Te Puna Industrial Park
297 Te Puna Station Road

**Stormwater Management and Flood
Modelling Review**

Bay of Plenty Regional Council

Figure 2: Stormwater layout³

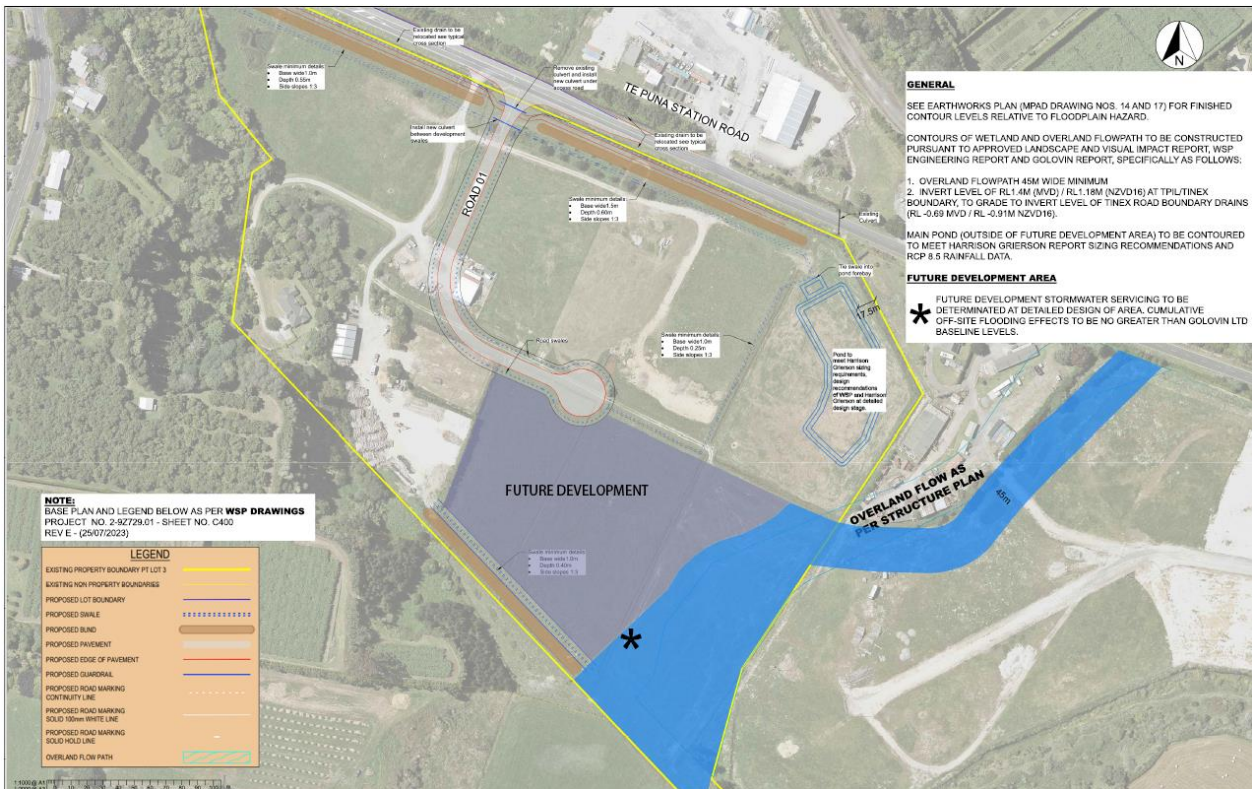
The wetland sizing is provided by WSP, and HG rely on this information within their reporting. The wetland is located above the flood plain as stated in the Golovin flood modelling reporting however below the flood level in the HG report and plans. Notwithstanding, there are some fundamental operational aspects as to the success of a wetland in the location shown in HG and Golovin reports. The wetland in HG report is located at a level of circa RL1.5m, whereas flood modelling has the top of the wetland at least RL3.0m. This outcome then brings the question of how attenuation is to be delivered if the wetland is fully inundated during the flood events.

- Location of the wetland in relation to ground water table.
 - Observed water level in the drain to which this wetland will discharge is circa 0.5m below ground surface level (April 2024)
- Attenuation within wetland in relation to the top water levels during rainfall events from the catchment (flood levels at the site⁴)
 - 10yr TWL 2.36mRL
 - 50yr TWL 2.87mRL
 - 100yr TWL 2.99mRL
- Wetland design parameters:
 - Permanent water depth 0.5m
 - Attenuation volume depth 0.5m
 - Emergency spillway provisions
 - Hydraulic connectivity to discharge point.
 - Tailwater effects
 - Lining wetland to provide separation to groundwater table.

The stormwater layout plan shows Future development in the southern portion of the TPIL site with an indicative location of a stormwater management device. There is no indication as to the design parameters or indeed the ability to deliver a device in this location. Based on the review of the anticipated communal wetland, above, the same technical aspects would need to be considered.

Figure 3: Proposed site features⁶

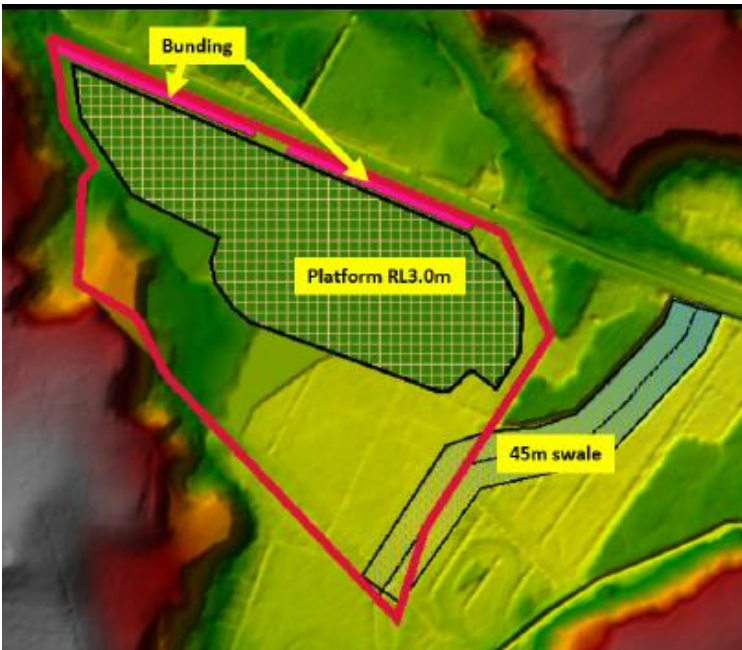
The future development shows possible filling in the flood plain; however, this has not been considered within the flood modelling undertaken by Golovin. The future development area is shown in MPAD drawing 13, which is in the southern portion of the site, as presented in the following figure.

Figure 4: Future development location.

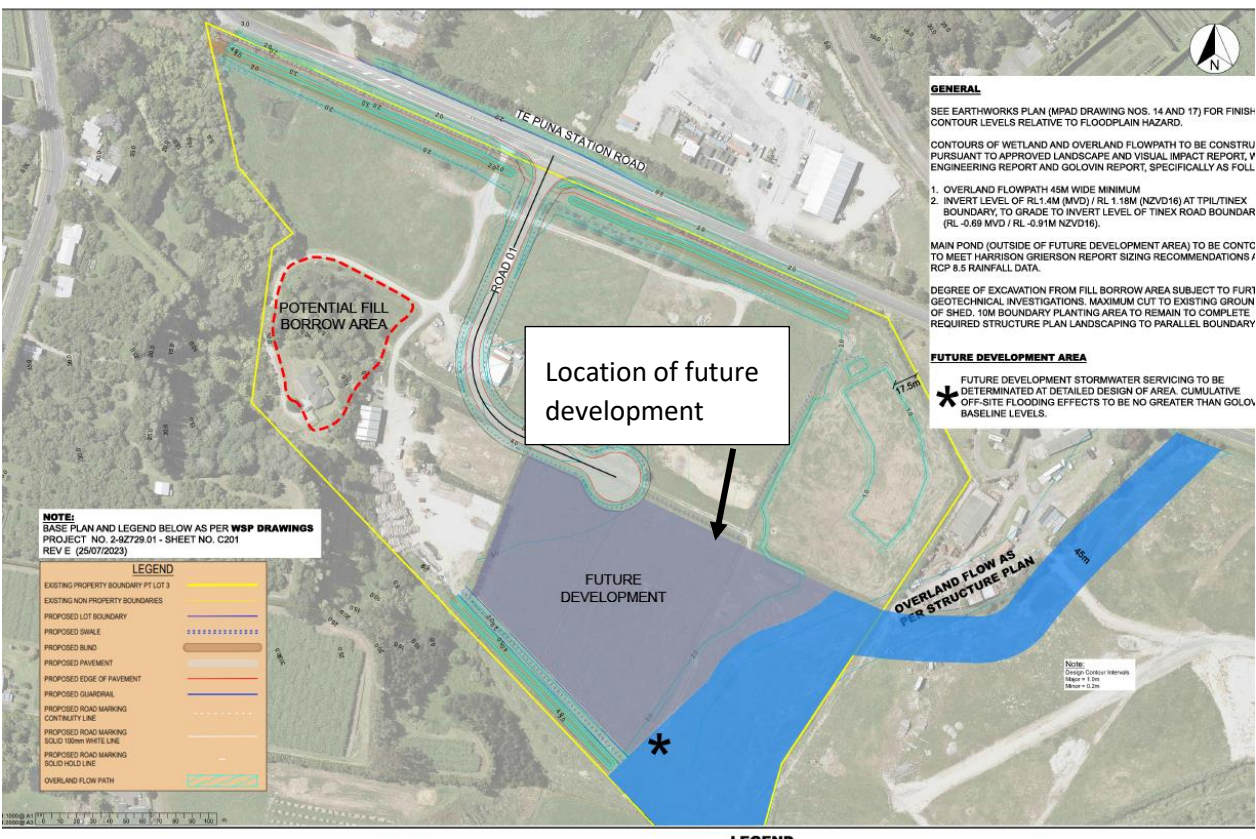
The future development area has not been included in the flood modelling therefore the effects or requirement for mitigation has not been assessed.

The Future development area is located in the flood plain however this scenario has not been modelled. The effects, due to the lack of information within the flood model outcomes, have not been assessed.
